RESOLUTION NO. 557

A RESOLUTION OF THE CITY COUNCIL OF THE CITY OF REDMOND, WASHINGTON, APPROVING THE PRELIMINARY PLAT OF WETHERSFIELD (PP-79-6) AND APPROVING THE HEARING EXAMINER'S RECOMMENDATIONS.

FINDINGS AND RECOMMENDATIONS  
OF THE HEARING EXAMINER OF THE  
CITY OF REDMOND

File No. PP-79-6

ALTERNATE "B" C-A-2

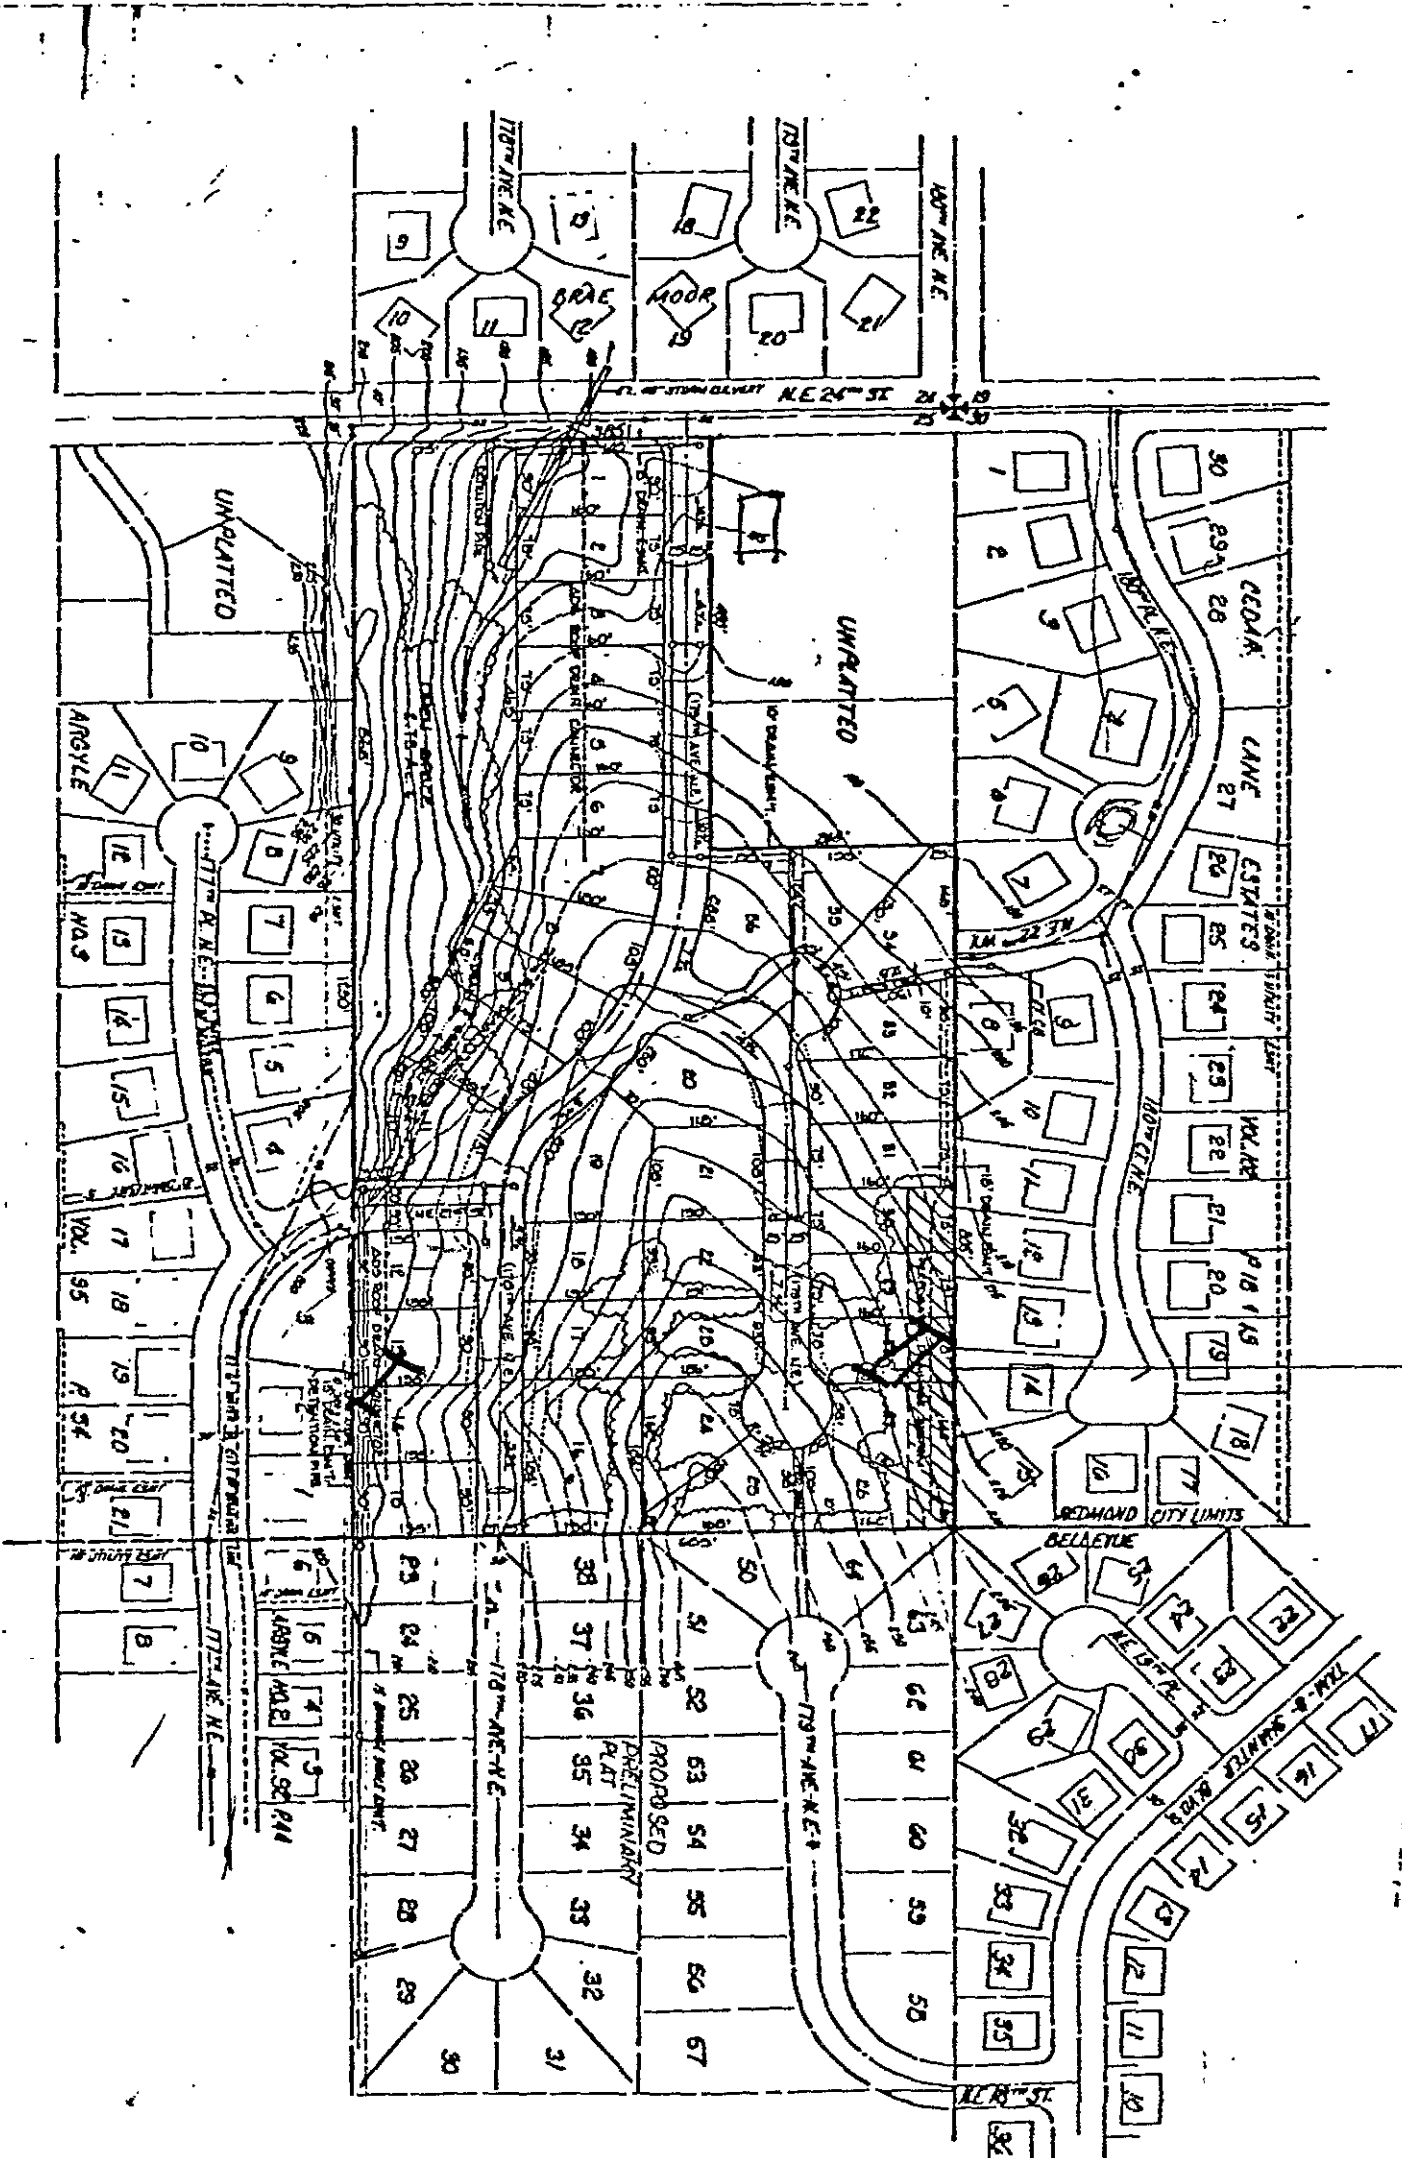
21. The traffic circulation as set forth in site plan identified as "Alternate B" is as follows: there is no access to the subdivision from the east or the south. Access from the west is via N.E. 21st Street which turns into 177th Avenue N.E. in the Argyle section of the City of Bellevue. Access from the north is via a turn-off off N.E. 24th Street onto 179th Avenue N.E. In the middle of the subdivision 179th Avenue N.E. divides, with 179th Avenue N.E. continuing to the east end of the subdivision and ending in a cul-de-sac in the southeast corner of the subdivision. 178th Avenue N.E. continues through the subdivision and cul-de-sacs south of the subdivision in the City of Bellevue. N.E. 22nd Way does not transect the subdivision in any manner whatsoever, and thus no vehicular access is provided to Cedar Lane Estates. Site plan "Alternate B" requires an east-bound deceleration lane and a west-bound left-turn pocket on N.E. 24th Street. The deceleration lane and the left-turn pocket are to be located near the intersection of N.E. 24th Street and 179th Avenue N.E.

22. Testimony in support of the traffic circulation in "Alternate B" was given by representatives of the Cedar Lane Estates Homeowner's Association, representing the development adjacent and north of the proposed Wethersfield subdivision. The basis of the testimony of the group was that "Alternate B" was an acceptable site plan for traffic circulation because the site plan did not allow access into Wethersfield subdivision from 178th Avenue N.E.

23. Evidence in support of the traffic circulation as proposed in site plan "Alternate B" was made by the Redmond Police and Fire Departments. A letter marked "City Exhibit No. 1" relating to such support was submitted as part of the record.

24. Testimony in opposition to the traffic circulation as set forth in "Alternate B" was given by the owner of a parcel of land located adjacent to the north-east corner of the Wethersfield subdivision. The basis for the opposition was the severity of the grade at the intersection of N.E. 24th Street and the proposed 179th Avenue N.E. and the fact that the intersection would be close to her property.

25. Testimony in opposition to the traffic circulation as set forth in "Alternate B" was also given by residents living on 177th Avenue N.E. in the City of Bellevue. The basis of the testimony was that 177th Avenue N.E. would become a collector of traffic and would thereby increase the traffic flow on 177th Avenue N.E. Also, increased traffic flow as 177th Avenue N.E. eventually turned into 179th Avenue N.E. would occur.

26. It is the recommendation of the City of Redmond Planning Department that if an entrance is made to the subdivision off N.E. 24th Street, it should be located as far to the east boundary of the site as possible in order to reduce the grade problem that would be caused by intersecting N.E. 24th Street with 179th Avenue N.E. at a lower point of the hill. Site plans "Alternate A" and "Alternate B" both have entrances off N.E. 24th Street. The entrance for "Alternate B" is located further to the east than that of "Alternate A."

27. The Engineering Department of the City of Redmond has recommended that the traffic circulation, as proposed in "Alternate B," is the most favorable of the three site plan proposals submitted.

37. It was a recommendation of the City Planning Department that the storm drainage system, as set forth in site plan "Alternate B," was the most acceptable to the City. Support of the drainage system, as set forth in site plan "Alternate B" was also expressed by witnesses including the Cedar Lane Estates Homeowner's Association.

38. An adjacent property owner to the proposed subdivision testified in opposition to the storm drainage system as set forth in "Alternative B." The basis of her opposition was that the proposed storm drainage system would be inadequate and would not collect the drainage properly, resulting in the drainage being directed to her property.

41. The native growth easement as set forth in site plan "Alternate B" extends from the southeast corner of lot 26 through the northeast corner of lot 30. A representative of the Cedar Lane Estates Homeowner's Association testified that the native growth easement should be extended through the northeast corner of lot 31. This recommendation was agreed to by the Redmond Planning Department and the Applicant.

That the site plan identified as "Alternate B" of the preliminary plat of Wethersfield be approved subject to the following conditions:

- G. A native growth easement, as shown on the site plan "Alternate B," shall be established in the southeastern corner of the Wethersfield subdivision and extend north to the northerly boundary of lot 31.

- A. N.E 179th Street adjacent to the "unplatted" section, as shown on "Alternate B," shall be depressed as much as reasonably possible and the north side landscaped and fenced (where necessary). A complete landscape and fencing plan is required at the time of final plat submittal for this area. The plan shall include evergreen (6 to 8 feet in height) and deciduous (8 to 12 feet in height) trees in an informal planting arrangement.
- B. The open space tract shall be noted as a native growth and stream preservation easement and included in the adjacent lots. The wording of this easement and the easement on the southeast portion of the lot shall be approved by the Department of Planning and Community Development.
